REMARKS

In response to the Official Action of January 25, 2005 slight amendment has been made to the specification to identify the abbreviations and acronyms GSM and Iu as used in the specification, as well as to amend the acronym TDMA to TDM with appropriate explanation thereof. No new matter is presented as explained below. Furthermore, Figure 2 has been amended in a manner requested in view of the objection to the drawings and claims 1-4, 14, 19 and 21 have been amended in a manner which is believed to distinguish all of the claims of the present invention over the cited art. New claims 27 and 28 are presented directed to a gateway device corresponding to the gateway device described in the telecommunications network and for similar reasons, is believed to be distinguished over the art. Support for newly submitted claim 27 is found in the originally submitted Figures 1 and 2, as well as set forth in the original specification, including page 7, line 19 through page 8, line 17. Support for new claim 28 is found in the original specification at page 8, lines 1-4. Support for the amended language in claims 1 and 21 is found in Figure 2 with the direct connection between access net

Fig. 2

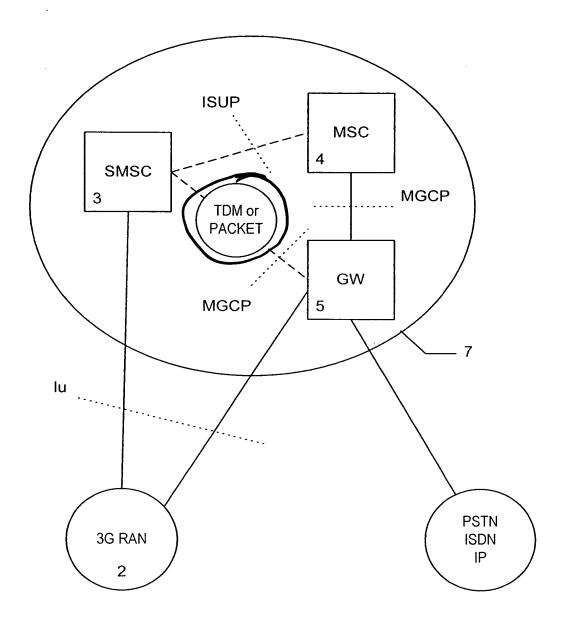
With regard to the TDMA network recited in claim 14, the acronym TDMA has been amended to TDM since it is a time division multiplex network and a corresponding correction has

been made in Figure 2. No new matter is presented since a time division multiplex network is well-known in the wireless communications art and also in view of the usage of the acronym TDMA in the originally presented specification and claims. The amendment to TDM is to more appropriately identify the network. The objected "packet network" not being shown with regard to its usage in claim 15 has been amended by presentation of such in Figure 2. No new matter is presented since the packet network was, as set forth in claim 15, presented in the original specification, including page 9, lines 5-7.

Figure 2 has been amended per the attached replacement sheet. The amendment to Figure 2 is shown in a copy of this replacement sheet highlighted to show the amendment.
